## dsPIC33EVXXXGM00X/10X Family Silicon Errata and Data Sheet Clarification

The dsPIC33EVXXXGM00X/10X family devices that you have received conform functionally to the current Device Data Sheet (DS70005144H), except for the anomalies described in this document.

FIGURE 1:

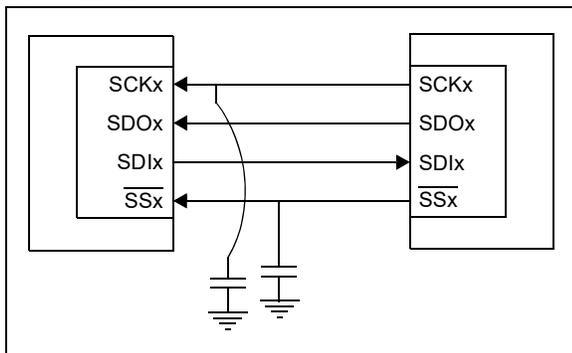
When the SPIx module is configured in SPIx Slave mode (MSTEN bit (SPIxCON1[5]) = 0), the frame slave (FRMEN bit (SPIxCON2[15]) = 1) and the SPIFSD bit (SPIxCON2[14] = 1), in Standard Buffer mode with the Clock Polarity Select bit, CKP = 0, the data are not transmitted in both 8-bit and 16-bit mode, but the data are being received correctly.

Adding a capacitance on the signal, as shown in Figure 1, will help the data to be received properly.

**FIGURE 2: TIMING DIAGRAMS FOR CENTER-ALIGNED AND EDGE-ALIGNED MODES**

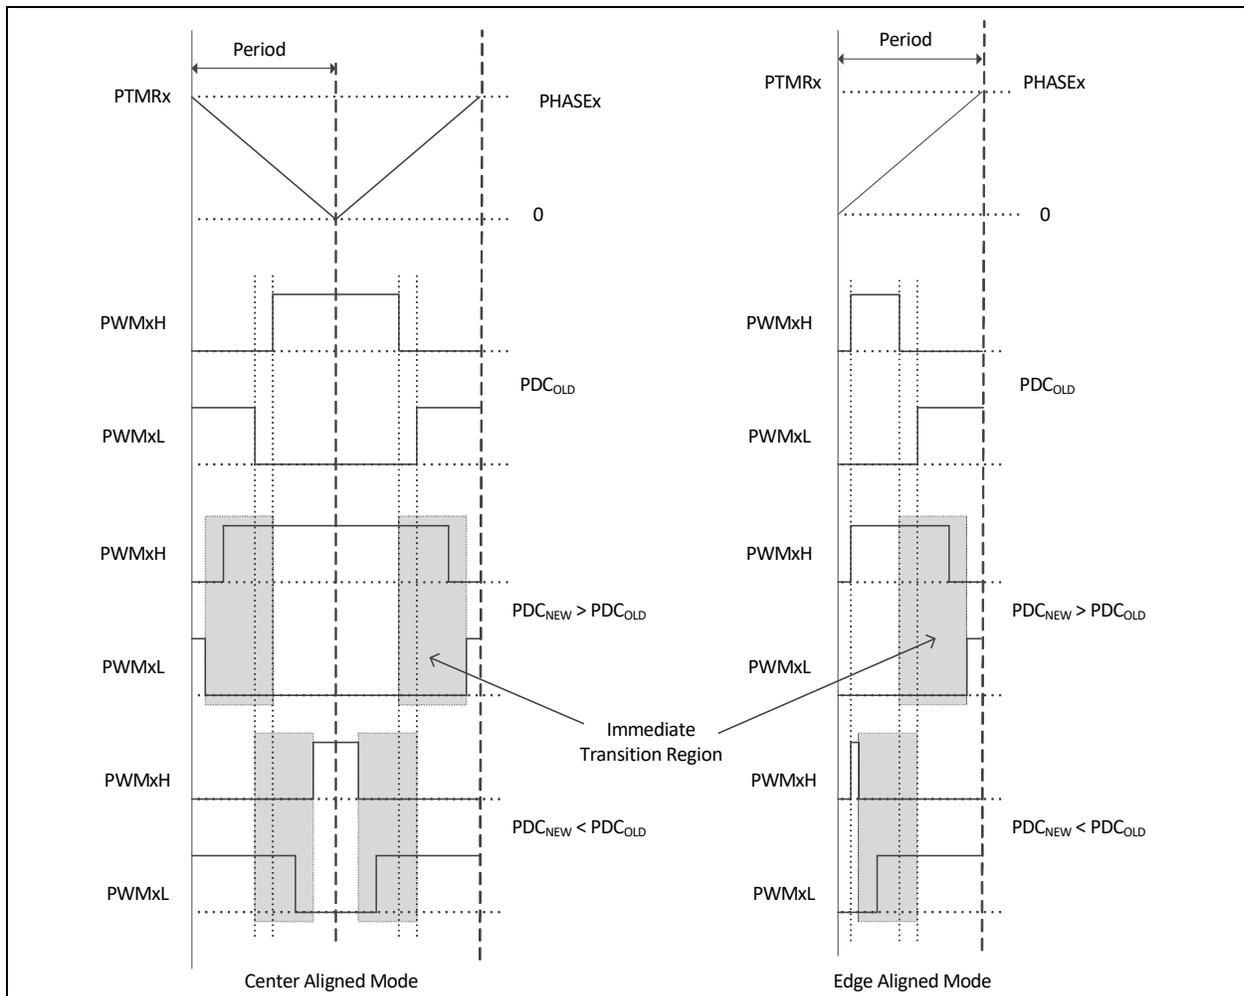
The PWM generator may not assert dead time on the edges of transitions. This has been observed when all of the following conditions are present:

In [Figure 2](#), if the duty cycle write occurred in the shaded box, then PWMxH and PWMxL will make an immediate transition without dead time.

However, in most applications, the duty cycle update timing can be controlled using the TRIGx trigger or Special Event Trigger, such that the above mentioned conditions are avoided altogether.

FIGURE 3: ILLUSTRATION OF 1 TOSC GLITCH WHEN PWM OVERRIDE IS TURNED OFF

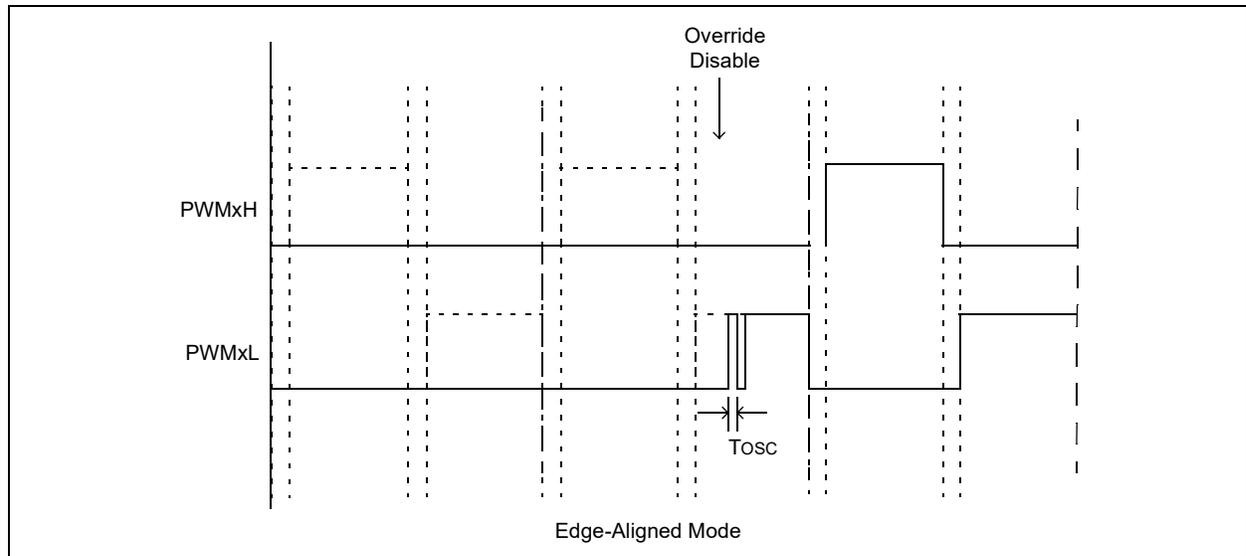
In Complementary mode after the PWM module is enabled ( $PTEN = 1$ ), if the PWM override is turned off, a one TOSC glitch will be present on the rising edge of either the PWMxH or PWMxL pins, whichever occurs first, as shown in Figure 3.

The glitch will be present on PWMxH/PWMxL every time the override state is changed from override enabled to override disabled. The width of this glitch is equal to one TOSC when  $PCLKDIV[2:0]$  ( $PTCON2[2:0]$ ) = 000. Increasing the PWMx input clock prescaler setting will increase the width of the glitch accordingly.

FIGURE 4:

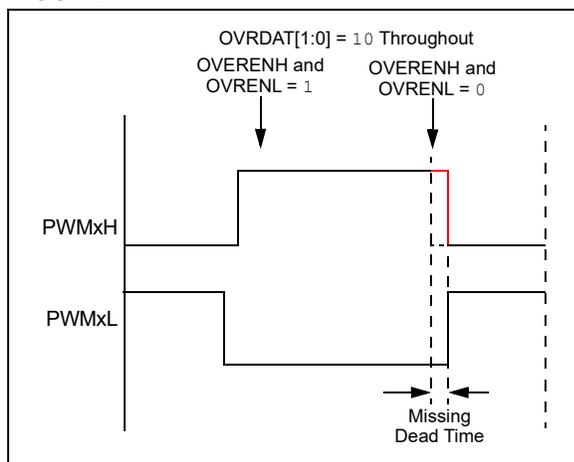
In Complementary Output mode, the expected dead time between transitions of the PWMxH and PWMxL outputs may not be asserted when the following occurs:

- Output override synchronization is configured to occur on the CPU clock boundary (IOCONx[0] = 0);
- Both PWMxH and PWMxL overrides are enabled prior to the event (OVRENH and OVRENL are both '1'), and
- Both overrides are disabled (OVRENH and OVRENL are both '0') at the instant the dead time should be asserted (Figure 4). This has been observed in both Center-Aligned and Edge-Aligned modes.

FIGURE 5:

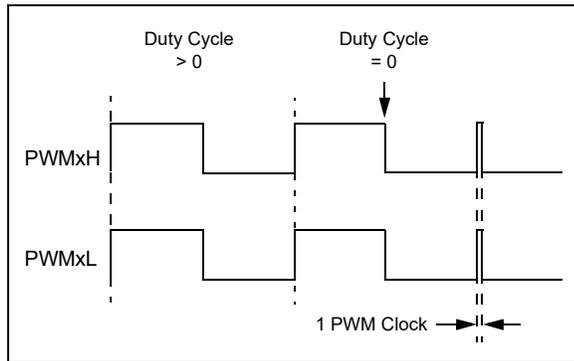
In the Redundant Output mode (IOCONx[11:10] = 10) and Push-Pull Output mode (IOCONx[11:10] = 01) with Immediate Update disabled (PWMCONx[0] = 0), when the Duty Cycle register is updated from a non-zero value to zero, a glitch pulse of a width equal to one PWM clock will appear at the next PWM period boundary, as shown in Figure 5, for the Redundant Output mode. Here, the Duty Cycle register refers to the PDCx register if PWMCONx[8] = 0 or the MDC register if PWMCONx[8] = 1.

1. Use the PWM override feature to override the PWM output to a low state instead of writing to the Duty Cycle register. In order to switch back to a non-zero duty cycle output, turn off the PWM override. The override-on and override-off events must be timed close to the PWM period boundary if the IOCONx register has been configured with IOCON[0] = 0 (i.e., output overrides via the OVDDAT[1:0] bits occur on the next CPU clock boundary).

2. Enable the Immediate Update (PWMCONx[0] = 1) while configuring the PWM module, i.e., before enabling the PWM module (PTCON[15] = 1). With Immediate Update enabled, writes to the Duty Cycle register can have an immediate effect on the PWM output. Hence, duty cycle write operations must be timed close to the PWM period boundary in order to avoid distortions in the PWM output.

**FIGURE 6:**

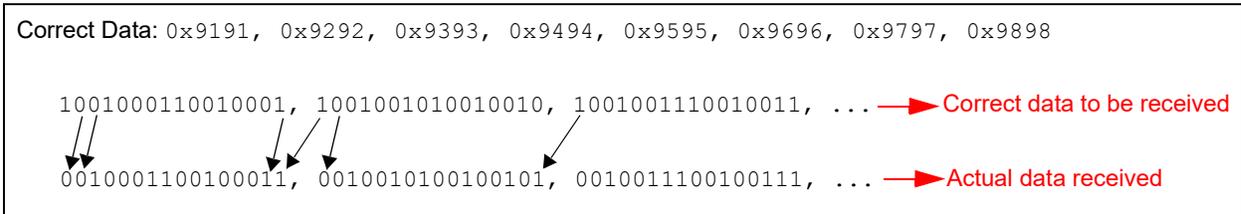
Received data of the SPI are sampled one clock cycle late for the following conditions:

For example, the correct data that should be received are 0x9191, 0x9292, 0x9393, 0x9494, 0x9595, 0x9696, 0x9797, 0x9898, but the actual data received are 0x2323, 0x2525, 0x2727, 0x2929, 0x2B2B, 0x2D2D, 0x2F2F, 0x3130 (Figure 6).

**FIGURE 7: SIMPLIFIED BEHAVIOR**

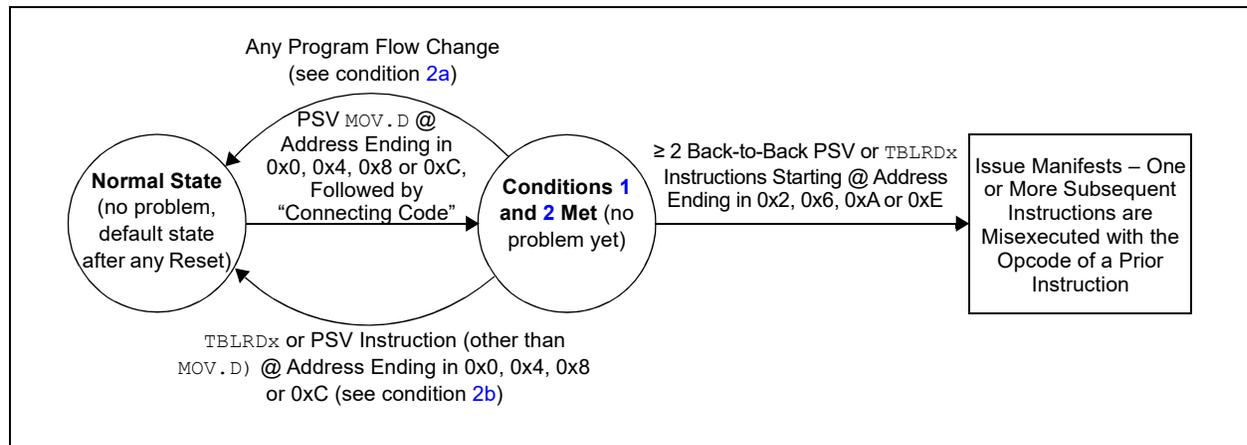
3.	≥ 2 back-to-back PSV or <code>TBLRDx</code> instructions are executed (following the code of condition 2), where the first of the back-to-back instructions is located at an address ending in 0x2, 0x6, 0xA or 0xE.

[Figure 7](#) provides an example of the effective behavior.

1. All instances of PSV `MOV.D` can be replaced with two PSV `MOV` instructions instead. Non-PSV `MOV.D` instructions acting on RAM/SFRs do not need to be modified; or
2. If not already present, a program flow change instruction (such as `BRA $+2`) can be inserted above back-to-back data Flash read sequences; or
3. Back-to-back data Flash read instruction sequences can be broken up by inserting a non-Flash read instruction (such as a `NOP`), in between the Flash read instructions; or
4. The alignment of the code can be shifted to avoid the required opcode location addresses.

C code built with MPLAB® XC16 Compiler Version 1.32, or later, implements the work around by default. However, if the application uses Assembly language routines, these should be manually modified to implement the work around. Additionally, if precompiled libraries are used, these should be built with XC16 Version 1.32 or later. For additional information, please visit: [www.microchip.com/erratum\\_psrds\\_psrds](http://www.microchip.com/erratum_psrds_psrds)
